# Quality Control Report

**Consultant** **Wahib Medanat** Consultant Engineers  
**Site Name** **Thahr Al Sarow Basic Boys - Jerash**  
**Package** **Package 2**  
**Contractor** **Dijlah Est. Construction Co.**  
**Tender No.** **10/2019/USAID/SKEP/3/2**

**Rep No.** **QC-22 07**  
**Date** **9 / 08 / 2021**

Door jamb

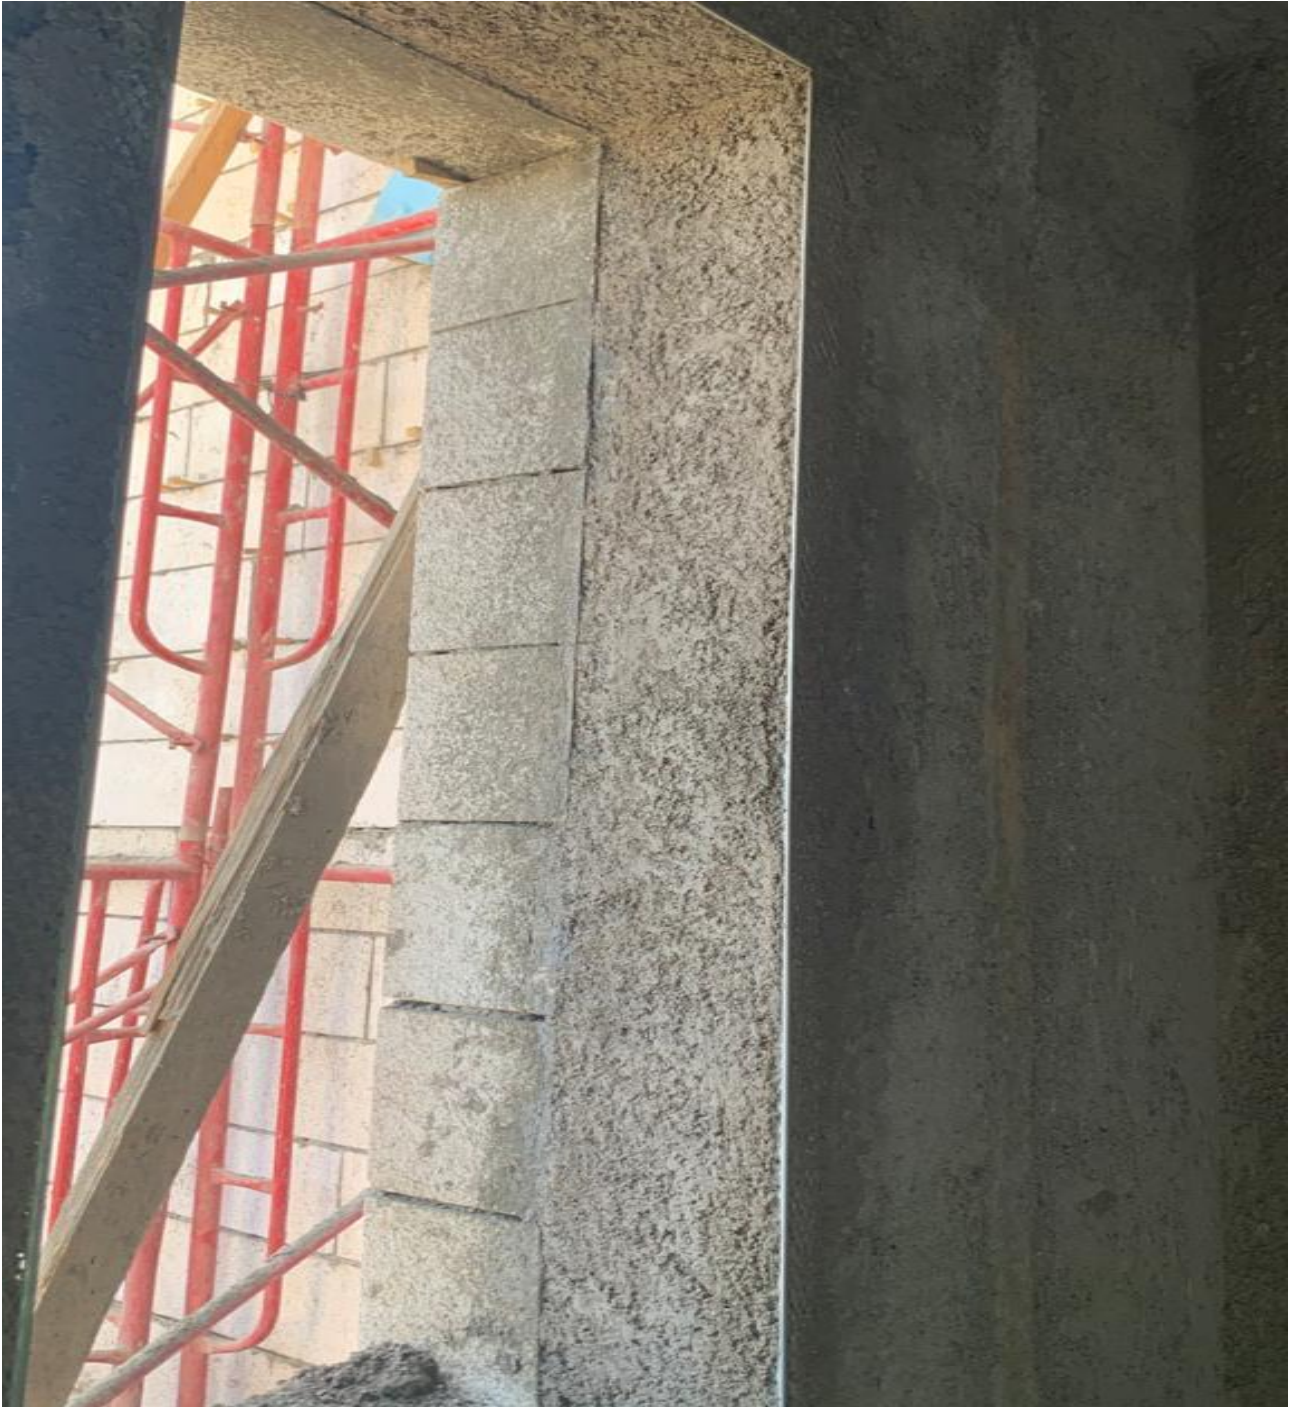
Description of Non Conformance	Corrective Action	Required by / When
<p>1. The end of block work at the door and window jamb is passing the end of stone limit. 2. Delivering to the site plastering beads 3 cm x 3 cm not complying with specifications.</p>	<p>1. Identifying the limit for both stone and block and rectify accordingly.                      2. Discarding those beads and deliver 5 cm x 5 cm new beads.</p>	<p>The Contractor/Immediately</p>
<b>Report Prepared by</b>	<p>Hassan Shaqbua, Supervision Quality Control Manager</p>	
<b>Contractor's Response</b>		
<p>The Contractor responded immediately.</p>		
<b>Notes</b>
